Before a Board of Inquiry  
MacKays to Peka Peka Expressway Proposal

Statement of rebuttal evidence of **Ann Williams** (Groundwater) for the NZ Transport Agency

Dated: 25 October 2012

Regional 3D Model Calibration Figure F4 Enlarged

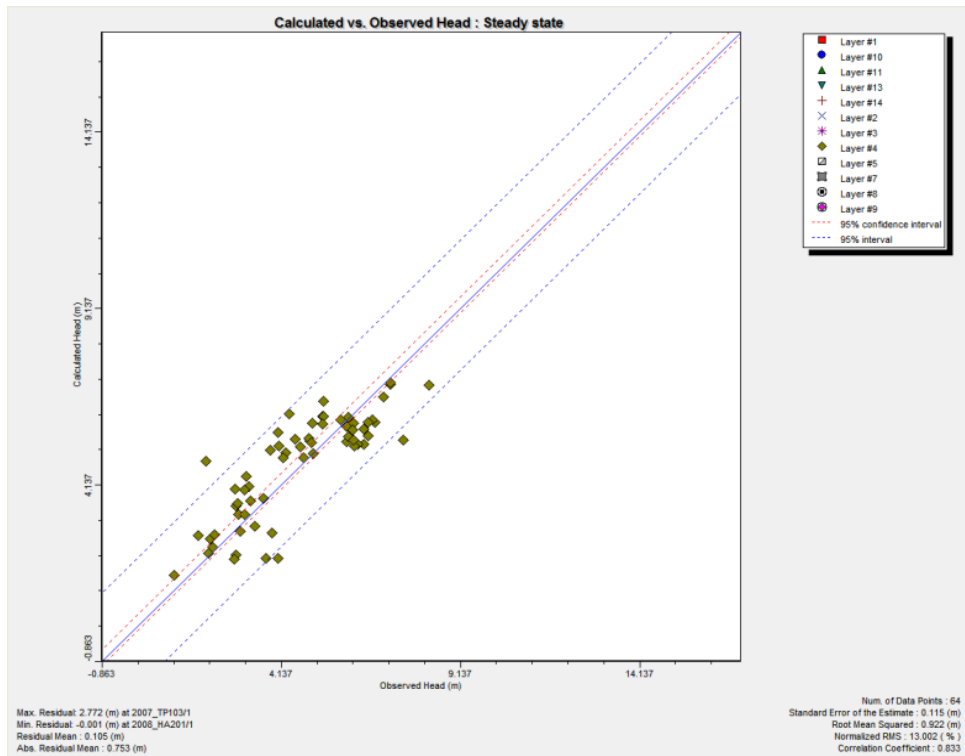
- 13.5 Mr Callander notes that the Layer 4 match of measured against modelled heads is "poor".<sup>7</sup> I attach an enlarged copy of the plot as well as a plot showing only layer 4 data points<sup>8</sup> as **Annexure C**. I note that many of the water levels for this layer were obtained from test pits, hand auger holes and private bores. The water levels recorded in them represent a single point in time, generally immediately following excavation or drilling and are therefore not necessarily representative of a particular soil layer or season. Water levels recorded in piezometers constructed and monitored as part of the Project commonly vary over a range of 0.5 m to 2 m. I therefore consider the calibration to be satisfactory.

**ANNEXURE E – CORRECTED FIGURES E1 (TECHNICAL REPORT 21)**

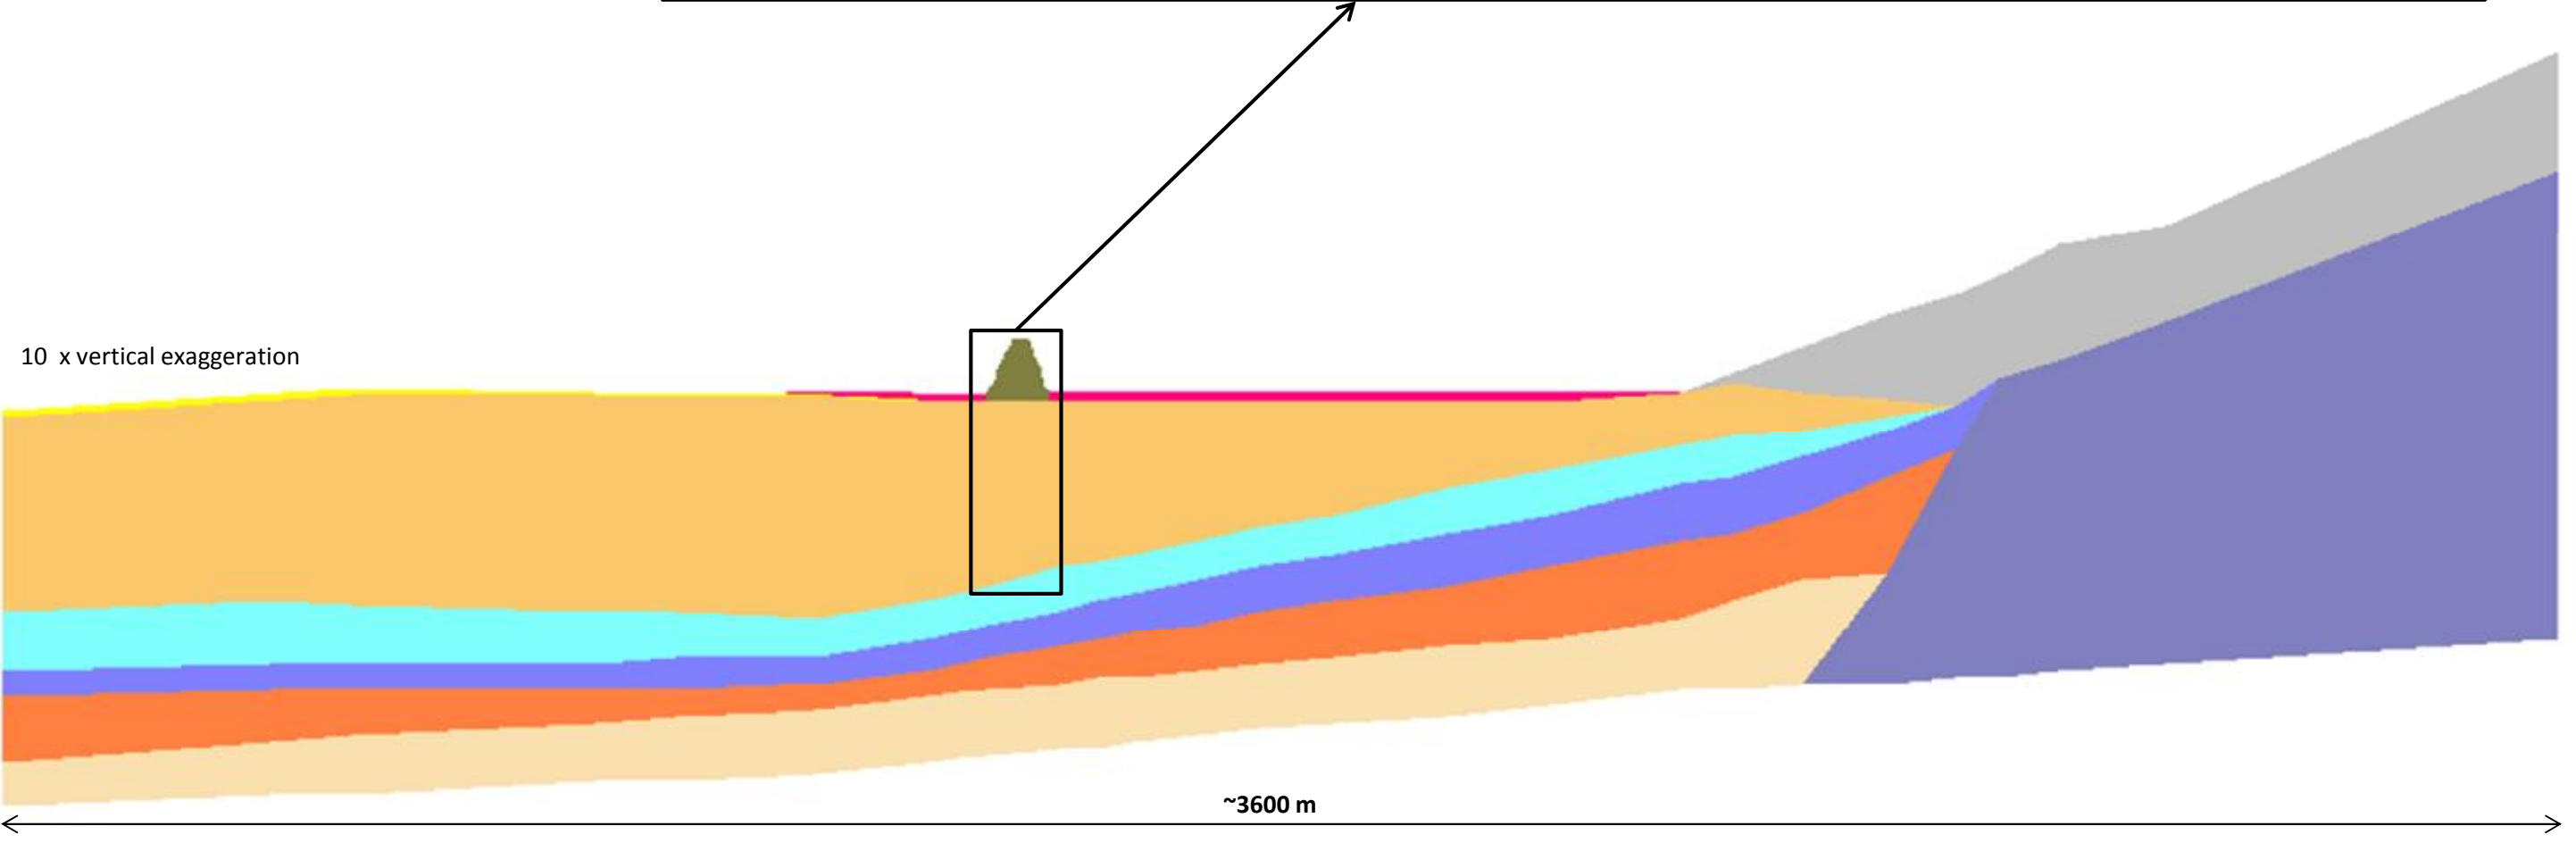
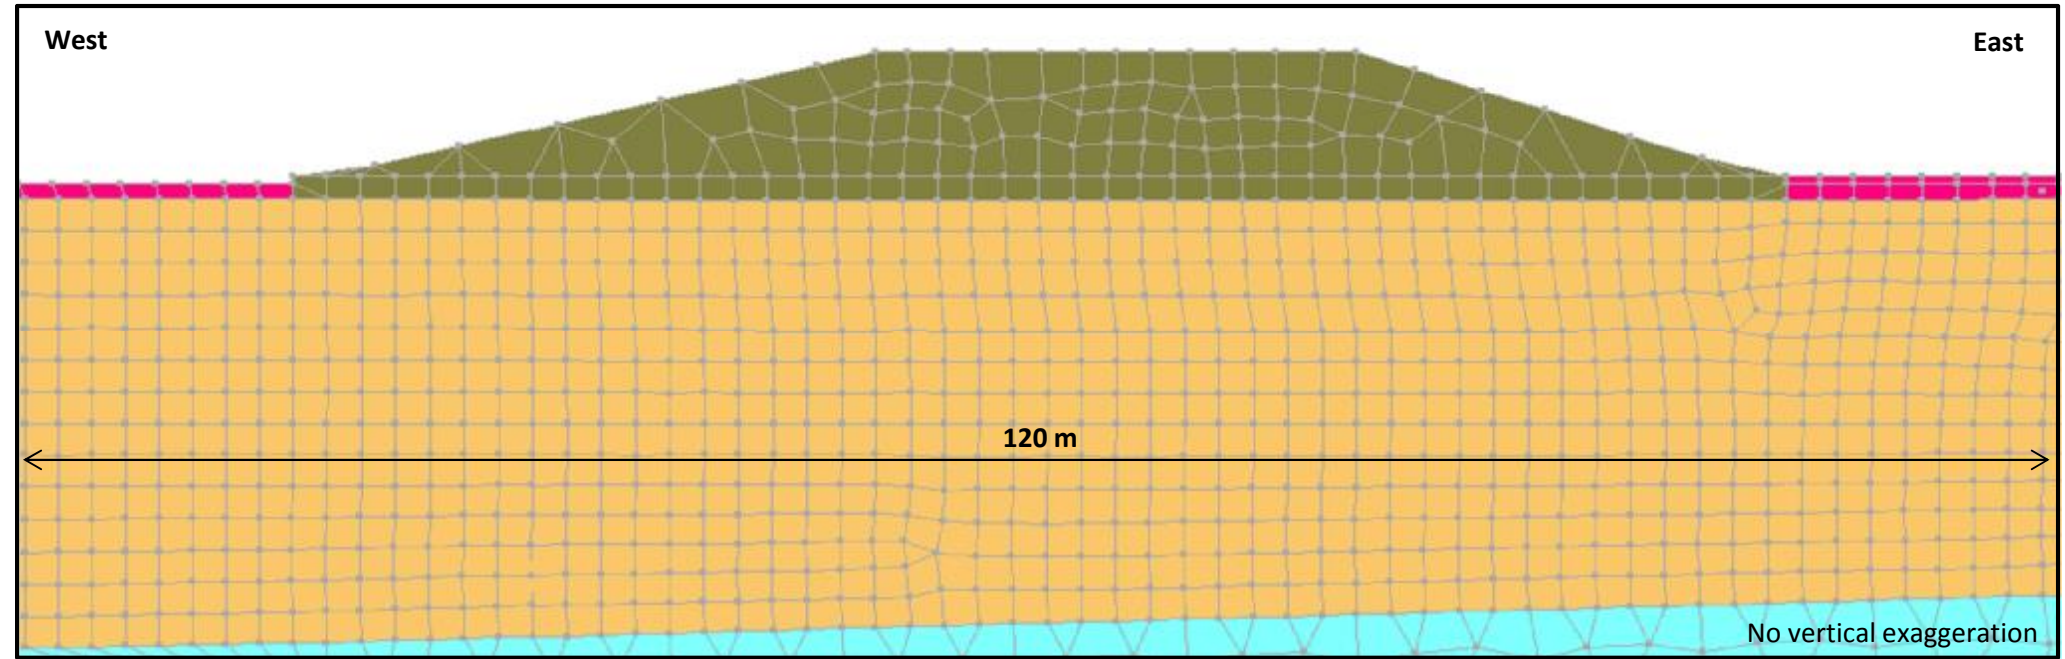
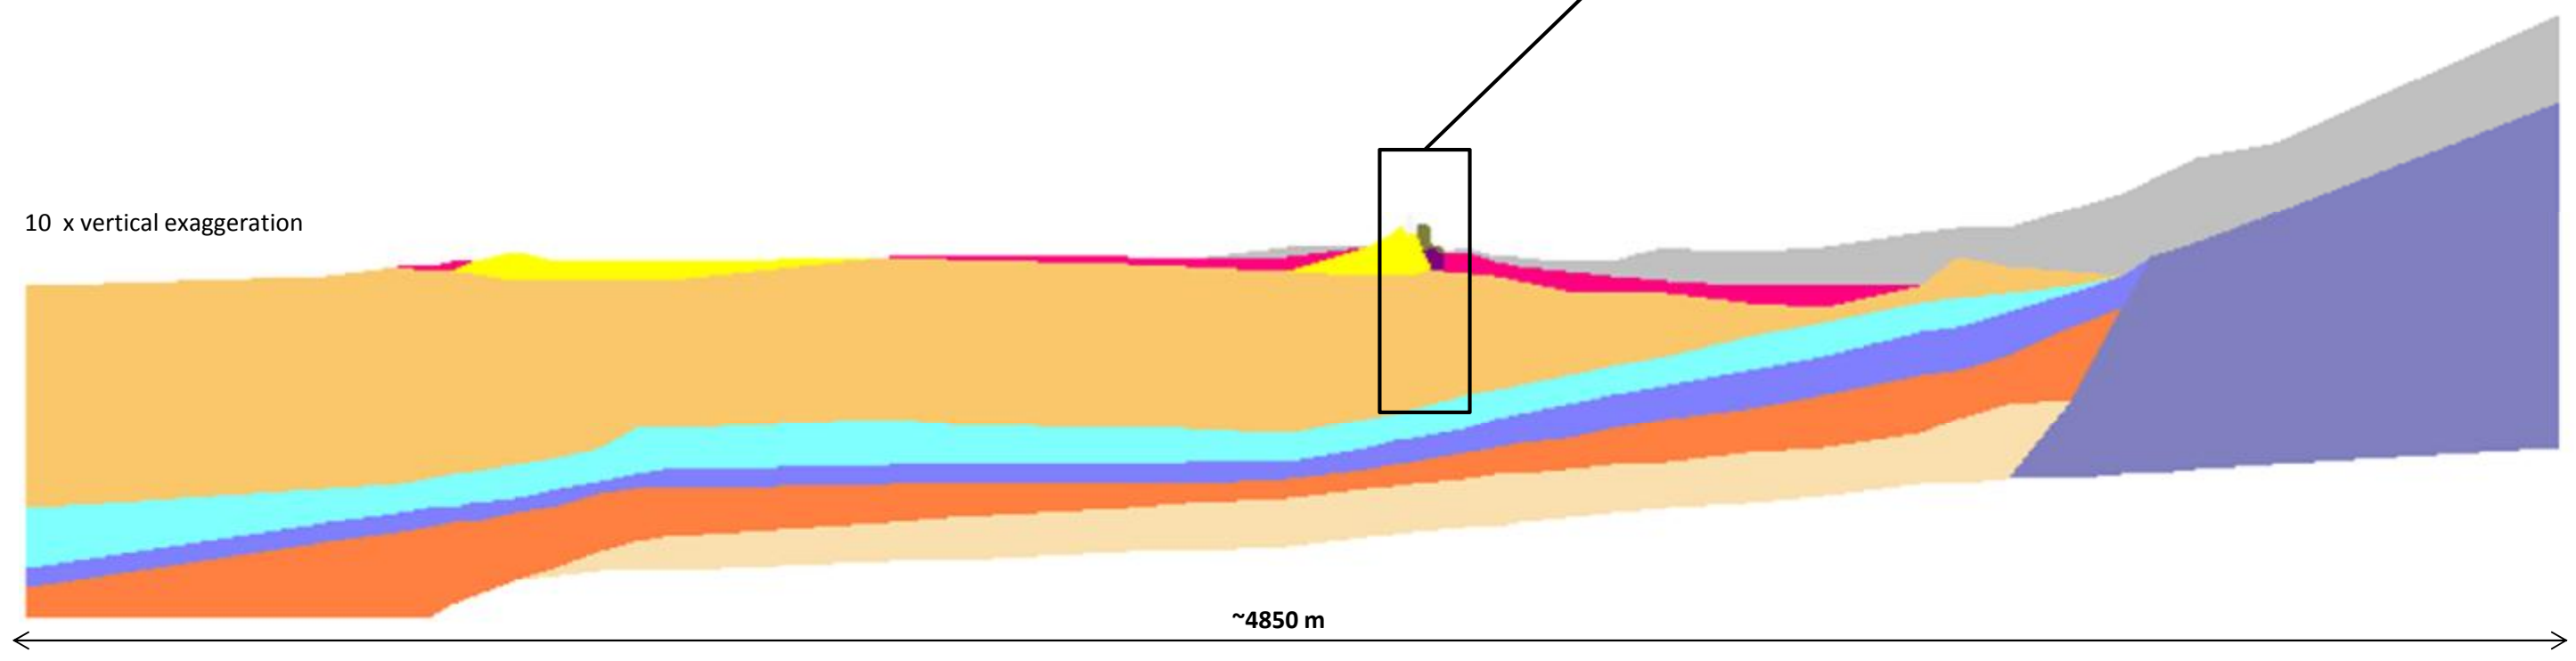
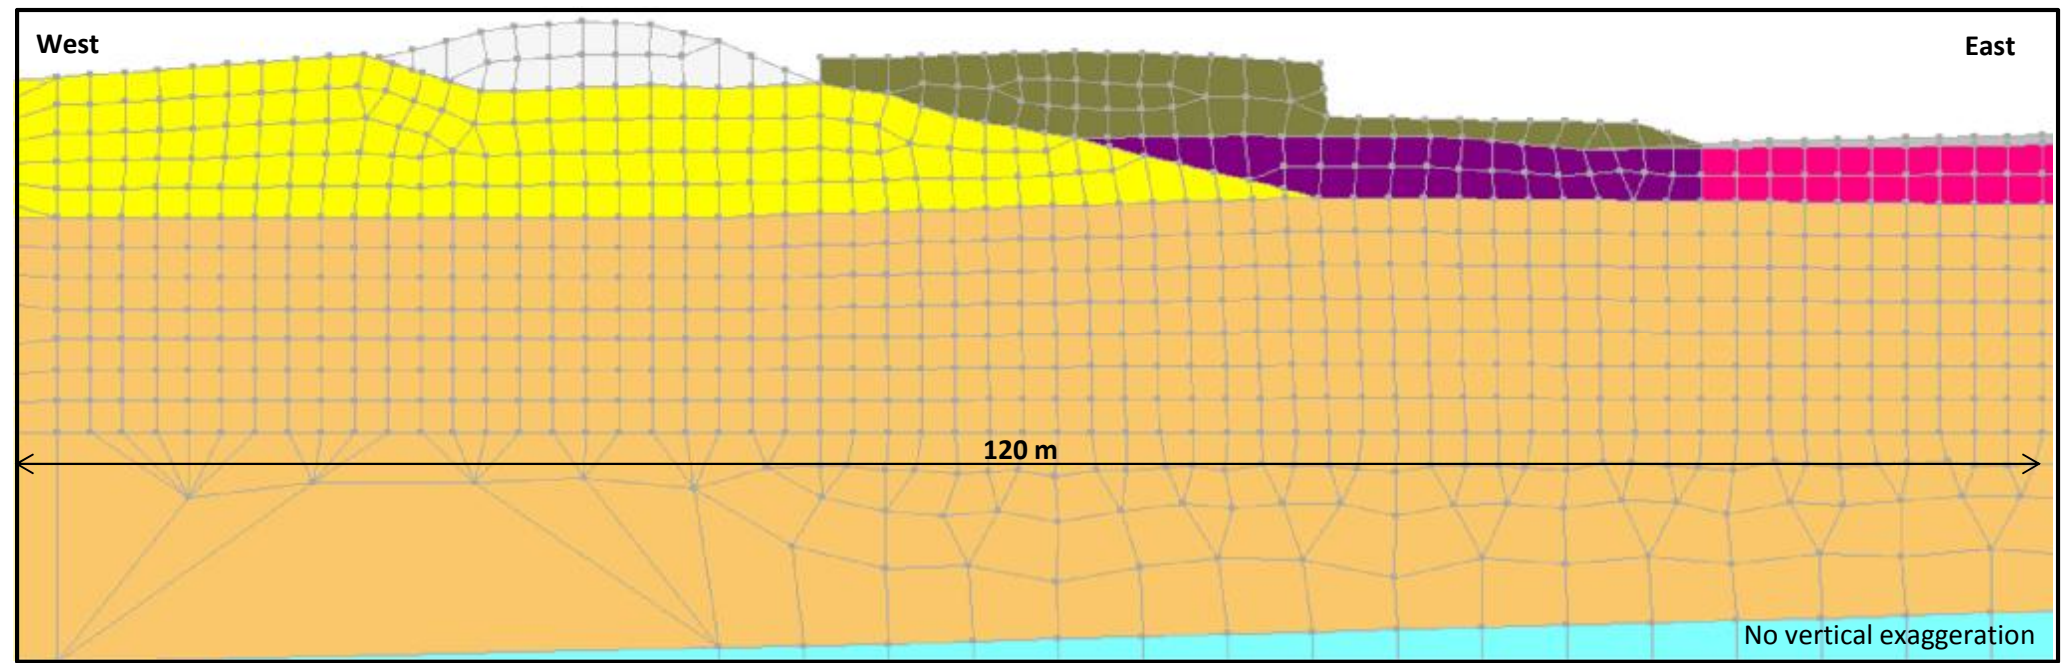
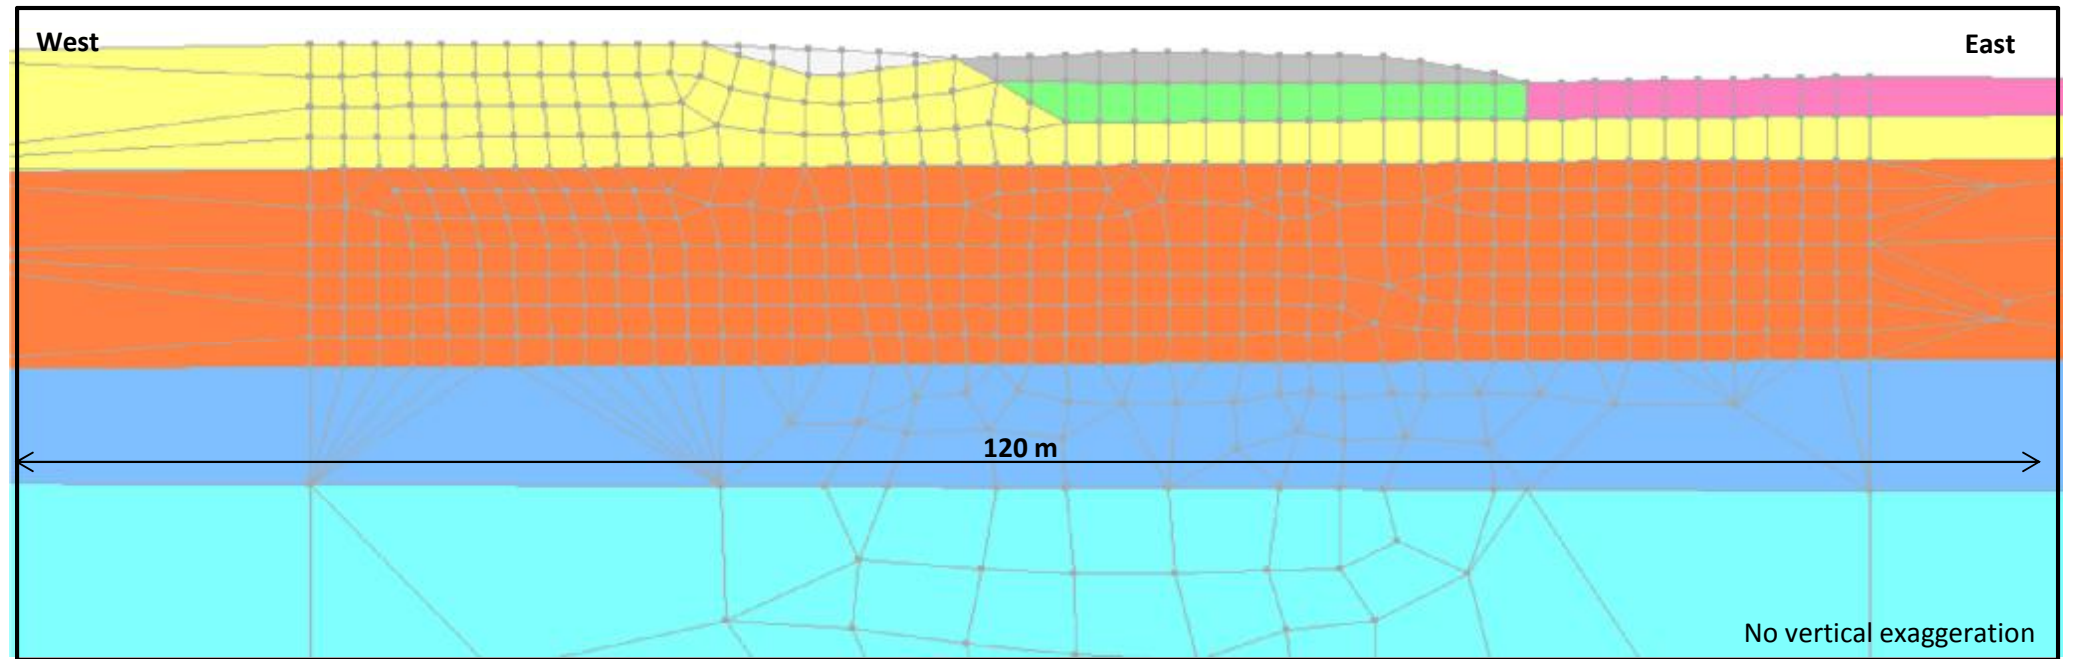
- 78 As Ms Rutter points out, there is an error in the labelling of the fill and greywacke in section CH5300 (Figure E1).<sup>65</sup> This is quite apparent but is corrected in **Annexure E** of this rebuttal evidence.<sup>66</sup>
